Z-66
(2015)

825 MARS HILL ROAD
LAND LOTS 269, 208, DISTRICT 2ND SECTION
COUNTY, GEORGIA

PETITION NO: Z-66

PROPOSED ZONING: R-20/OSC

DATE:	
SCALE:	
SHEET NO.:	
SITE PLAN:	
OSC (R-30) LAYOUT:	
PROJECT TO:	FIELD BOOK
DESIGNED BY:	DEVELOPER
DATE:	07.13.15
SCALE:	1"=100'
CHECKED BY:	
DATE:	
CHECKED BY:	
DATE:	
SCALE:	N/A

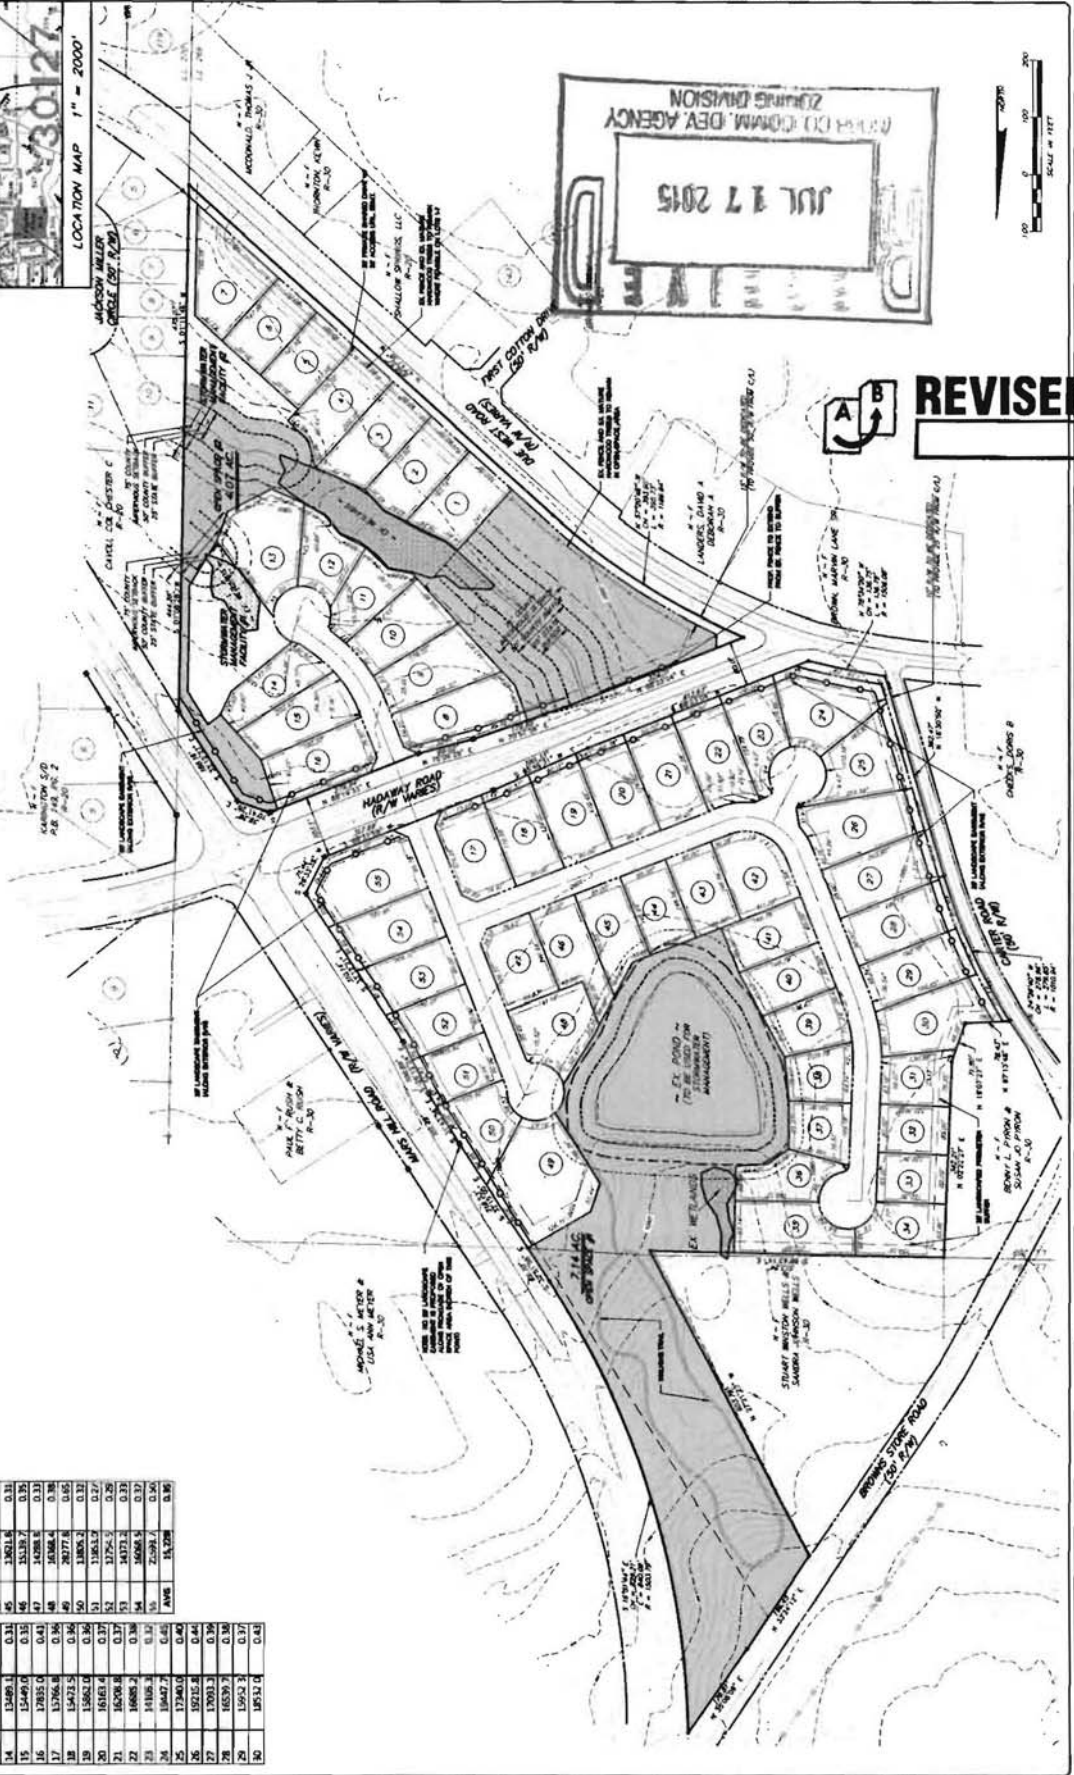
1. Site Plan stamped received on May 7, 2015 does not currently meet the requirements for R-20 Open Space Community, which requires 35% open space. The submitted plan provides 11.21 acres. Required open space for this plan would need to be 12.35 acres.

2. Lots 1 through 4 and a portion of 5 are located within the 25’ state stream buffer and the 50’ county stream buffer. All stream buffers must be within the open space.

3. Open space shall be designed to provide connection to adjacent property when the adjacent property is currently undeveloped or consists of established open space or conservation area. Contiguity of open space is highly desirable. Need to design connection of open space between the tract on the north side of Hadaway Road and the tract on the south side of Hadaway Road.

- FEMA Designated 100 year Floodplain Flood.
- Flood Damage Prevention Ordinance DESIGNATED FLOOD HAZARD.
- Project subject to the Cobb County Flood Damage Prevention Ordinance Requirements.
- Dam Breach zone from (upstream) (**onsite**) lake - need to keep residential buildings out of hazard.

Location: identified on site plan

- No Stormwater controls shown _____
- Copy of survey is not current – Additional comments may be forthcoming when current site conditions are exposed.
- No site improvements showing on exhibit.

2. There is an existing farm pond located on the northern portion of the site. This dam will be required to be brought up to current Cobb County design standards.
